File: vetrnik-control.kicad_pcb

Title: vetrnik-control

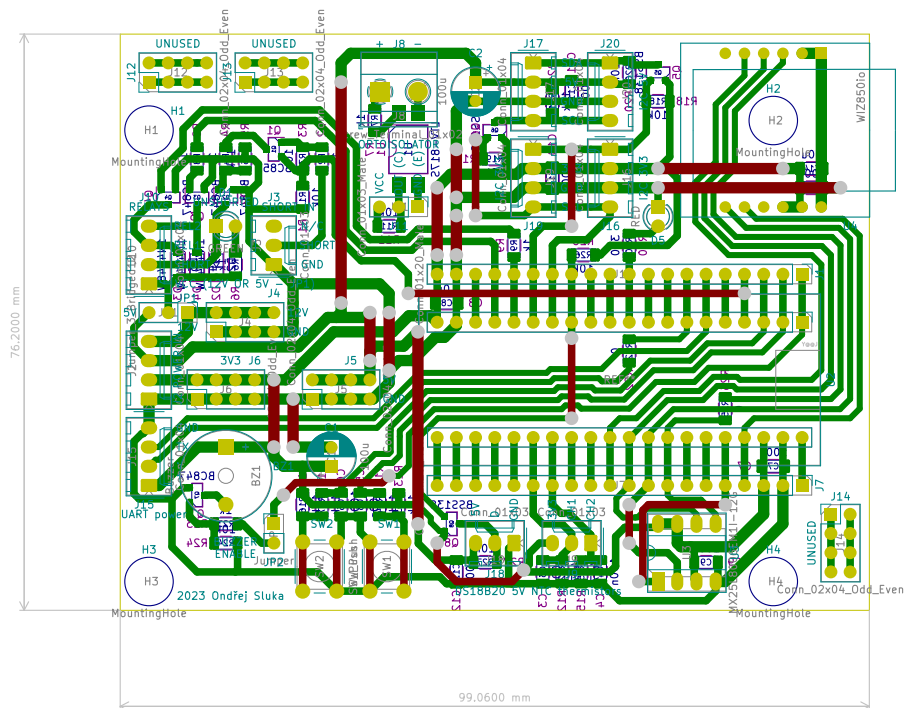
TODO this is the layout for the prototype, there have been several modifications since then.
A redesign is needed if a new board is to be made.

TODO why is H2 moved 1.27mm off its intended position?
TODO: next time, do NCC (non-copper clearing) around optocoupler
